STAFF REPORT

SUBJECT: H-2020-0017 Quartet Northeast
H-2020-0018 Quartet Southeast

LOCATION: 4020 & 4340 N. Black Cat Rd. [Parcels:
#S0434233652; S0434244210;
S0434233920; S0434325860 (partial), in
the west ¼ of Section 34, T.4N., R.1W.]

D. Landscape Plan (date: 1/30/2020)

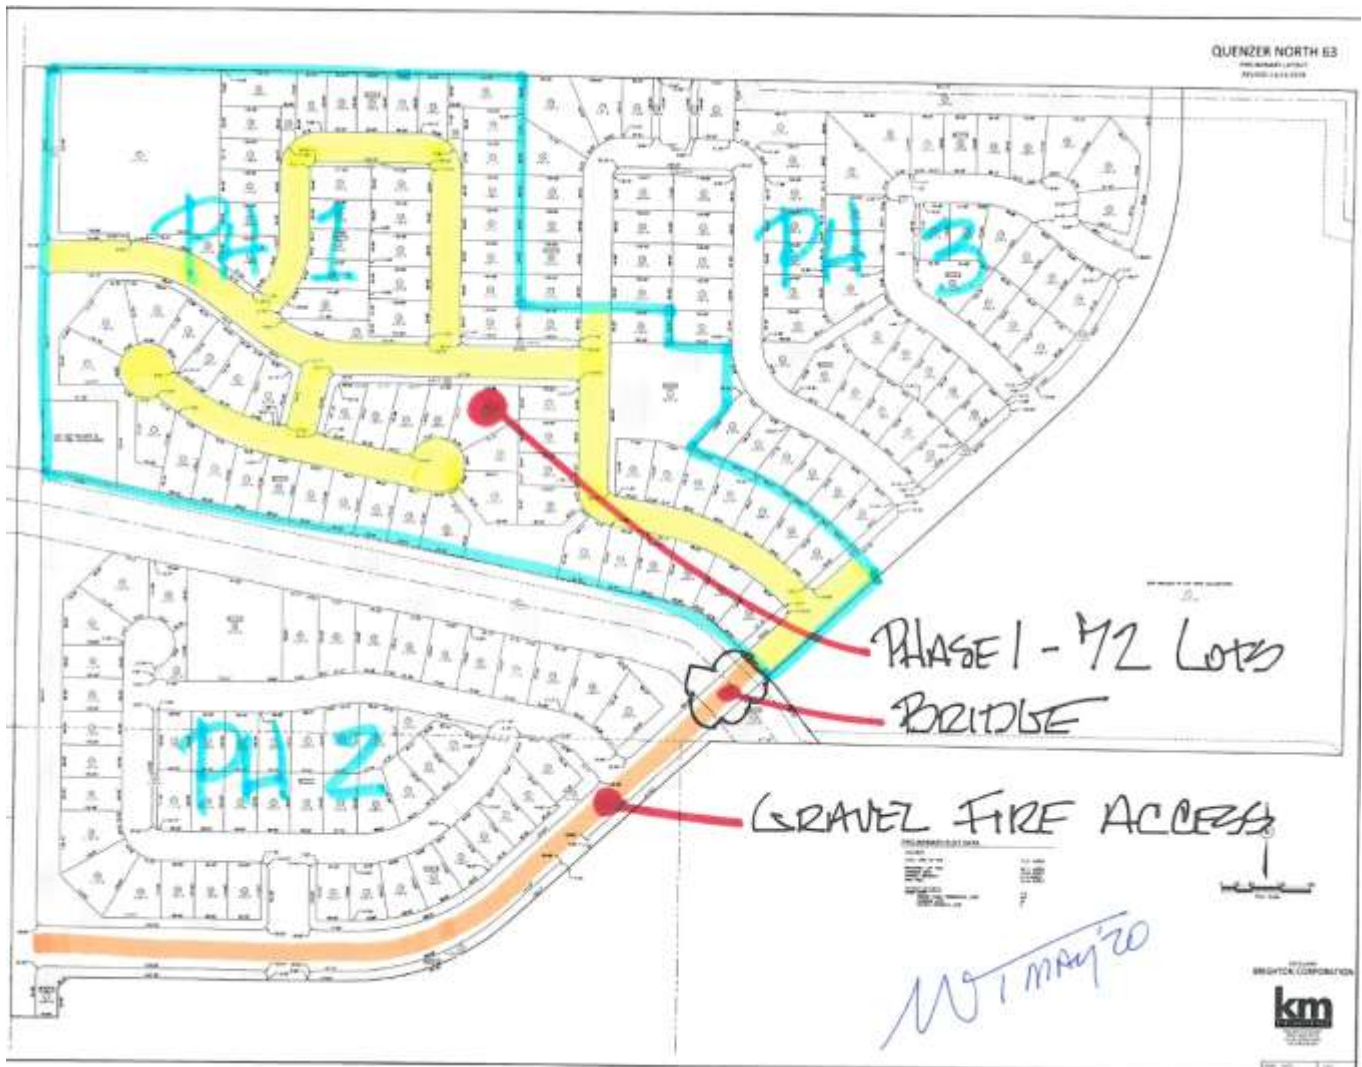
Staff recommends pedestrian pathways are provided from the internal sidewalks along Miramonte Ct. and Miramonte Dr. through adjacent common areas to the multi-use pathway along the Five Mile Creek; and micro-pathways are provided through Lot 10, Block 4 and Lot 7, Block 3 for pedestrian interconnectivity within the subdivision.

The Creason Lateral runs across the eastern portion of the north boundary of Quartet Northeast subdivision in Lot 34, Block 4 within a 40-foot wide easement and is proposed to be left open. **Because this area is included in the qualified open space calculations for the site, it should be landscaped per the standards listed in UDC 11-3G-3E – no landscaping is depicted on the landscape plan for that area.**

Six-foot tall solid wood fencing is proposed along the perimeter boundary of the site and along side yards adjacent to the street; and 5-foot tall clear vision fence is proposed adjacent to most internal common open space areas. **To provide more visibility of the common area on Lot 34, Block 4 where the Creason Lateral is located, Staff recommends fencing adjacent to the common lot complies with the standards listed in UDC 11-3A-7A.7.**

3. The landscape plan submitted with the final plat application shall be revised as follows:
 - a. Add pedestrian pathways from the internal sidewalks along Miramente Ct. and Miramente Dr. through adjacent common areas to the multi-use pathway along the Five Mile Creek; provide breaks in the fence where necessary to provide a connection. Also provide micro-path connections through Lot 10, Block 4 and Lot 7, Block 3 for pedestrian interconnectivity within the subdivision.

- f. The location of site amenities shall be depicted on the plan; a detail shall be submitted for the children's play equipment.
 - g. Depict landscaping in Lot 34, Block 4 in accord with the standards listed in UDC 11-3G-3E.

- h. Depict fencing on Lot 34, Block 4 where the Creason Lateral is located per the standards listed in UDC 11-3A-7A.7 to provide more visibility of the common area.
